## URGENT FIELD SAFETY NOTICE

RE: Lullaby Resus plus - positive end expiratory pressure (“PEEP) maintained at the end of the T-piece is lower than what is displayed on the Manometer”.

### 1 Addendum – Manometer reading offset correcting procedure, to be done before every patient use

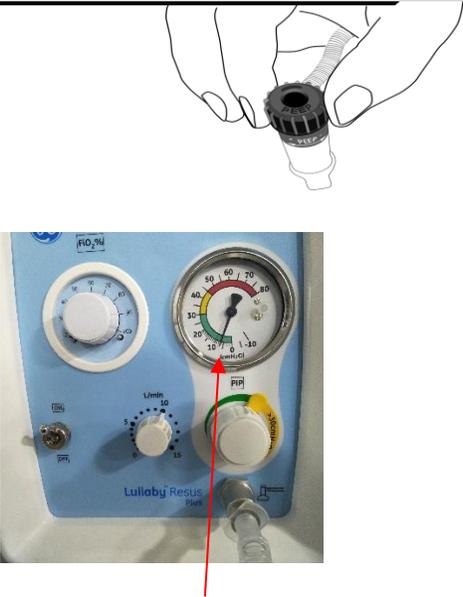
CAUTION: Do not try to open/dismantle/dis-assemble the device to correct the offset observed in Manometer reading
---	---

CAUTION: Offset Pressure should be noted only when the T-piece is not connected to the device.
---	--
